NPS FINAL ACCESSIBILITY INSPECTION REPORT

PROJECT & CONTRACT NO. SAFR 102086 Rehab failing amphitheater

DATE OF INSPECTION: 6/24/2010

Sketch 1:

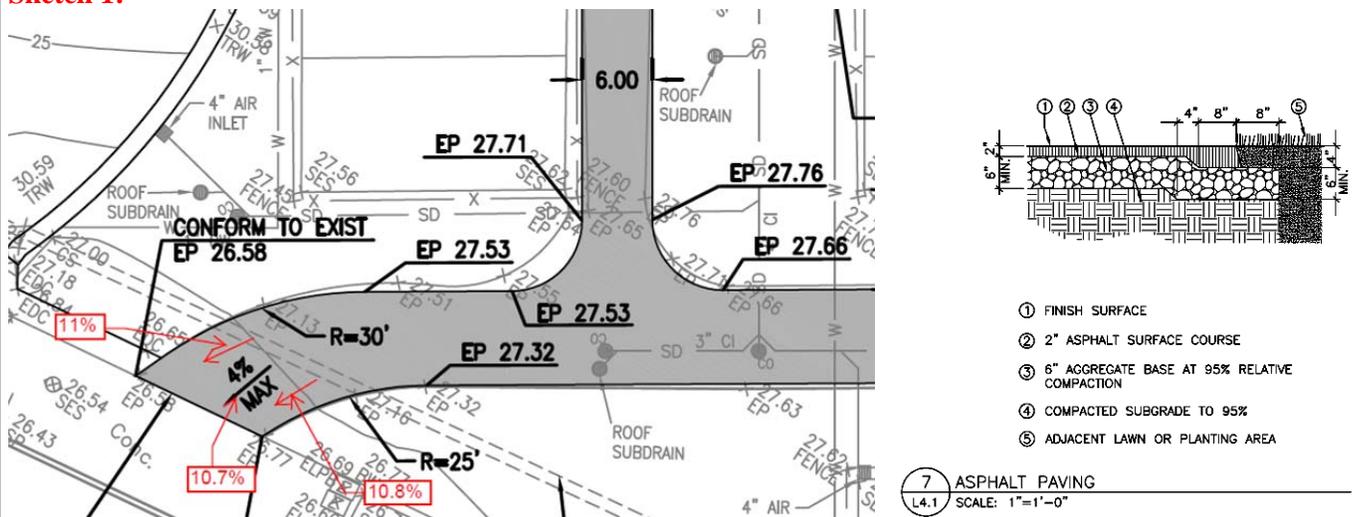
| b) | <input type="checkbox"/> | <input checked="" type="checkbox"/> | <input type="checkbox"/> | Running slope of all walking surfaces on the accessible route is 1:20 (5%) or less. 12' length of walk from museum sidewalk toward bleachers is graded at 11%, designed at 4% max. See sketch 1 below. |

Location/Notes: **Walk constructed in Sketch 1 above does not meet requirements for accessible ramp.**

Yes	No	N/A	
a)	<input type="checkbox"/>	<input checked="" type="checkbox"/>	<input type="checkbox"/>	Running slope is 1:12 (8.33%) or less. Measured at 2-foot intervals. 11%

b) Deficiency: Walk from existing sidewalk toward bleachers is too steep. 11% slope, designed at 4% max

Corrective Actions Needed/Taken: Verify walk slope cannot be reduced, add ABAAS compliant walk at less than 5% from east bleacher walk to sidewalk adjacent to bus shelter.

Sketch 2:

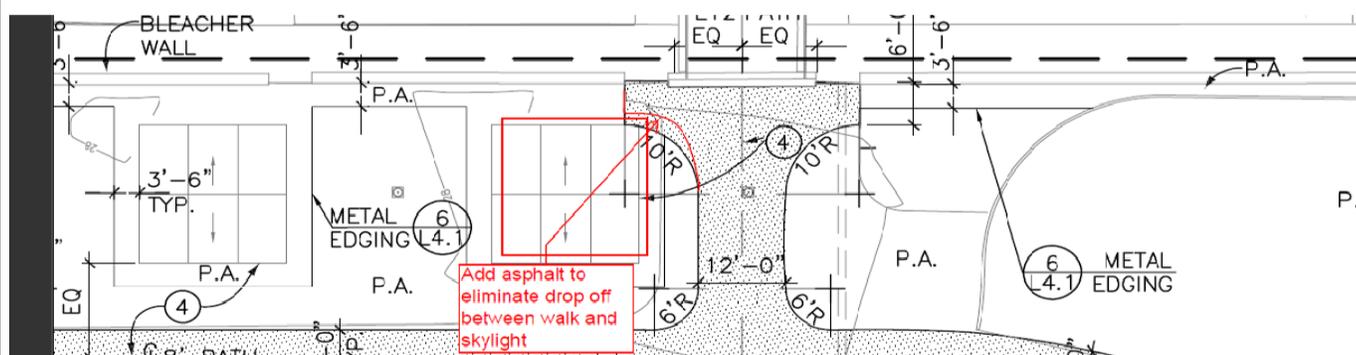
| c) | <input type="checkbox"/> | <input checked="" type="checkbox"/> | <input type="checkbox"/> | Cross slope of walking surfaces is 1:48 (2%) or less. Center walk to central bleacher cross slope is 4% or more at entrance to bleacher. Drop off at walk edge is 6". See detail below for project requirement. See sketch 2 below. |

h) Deficiency: East walk to Central bleacher has steep cross slope and 6" drop off, walk width not as shown on layout plan.

Corrective Actions Needed/Taken: Extend walk to skylight, provide 2% or less cross slope and fill in lawn or planted areas to be flush with walk as detailed.
